Town of Fort Myers Beach

RE: DCI17-0001 Sufficiency Review

DCI17-0001 Sufficiency Comments:

TO: Kara Stewart, Community Development Director, Town of Fort Myers Beach
FROM: Bill Spikowski
DATE: August 2, 2017
SUBJECT: Review Comments on Rezoning Application DCI 17-0001 from TPI-FMB

Pedestrian Bridge at Don Cesar, St. Petersburg Beach

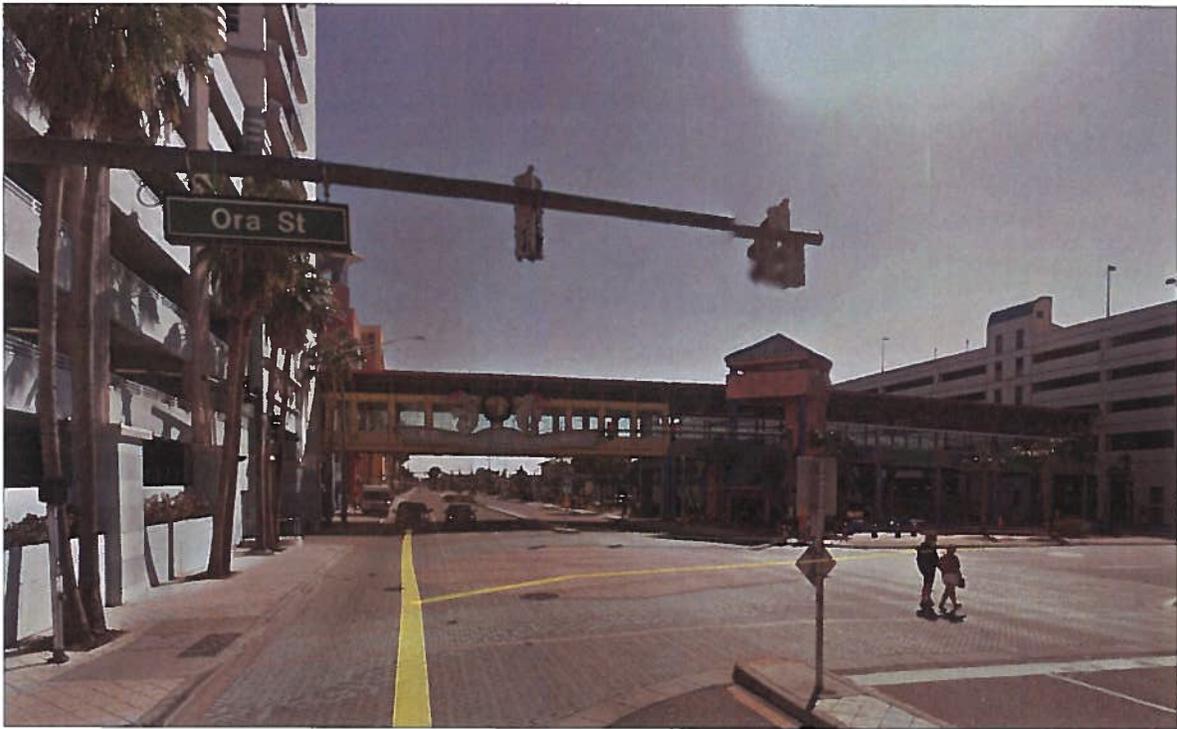
- The most important is the visual impact of the bridge over Estero Boulevard. On the positive side, the renderings show an attractive structure with a very open design, which would encourage the public to use it at least once for the vista it would provide. This bridge would connect two buildings that are extremely large for Fort Myers Beach and would be built very close to Estero Boulevard at its narrowest point; together they would create an imposing gateway effect for people approaching from both directions. It is difficult to anticipate whether this would be perceived positively by people with no connection to the resort.

- Because the Estero Boulevard bridge would cross a county right-of-way, the county would have to give permission for the bridge. The applicant has confirmed at least one discussion with the county about this but has not divulged anything further about that meeting or what process the county would require to grant permission. Issues would undoubtedly include structural integrity, clearance above the street, safety, insurance, liability, etc. The same issues would be addressed by the town for the bridge over Fifth Street.
- The town would likely want control over the initial design of both bridges and over future changes such as enclosing the bridges or changing their appearance. Continuing public access to the bridges would be another issue, also technical issues such as how the stairs and elevator on each end would relate to existing and future sidewalks.
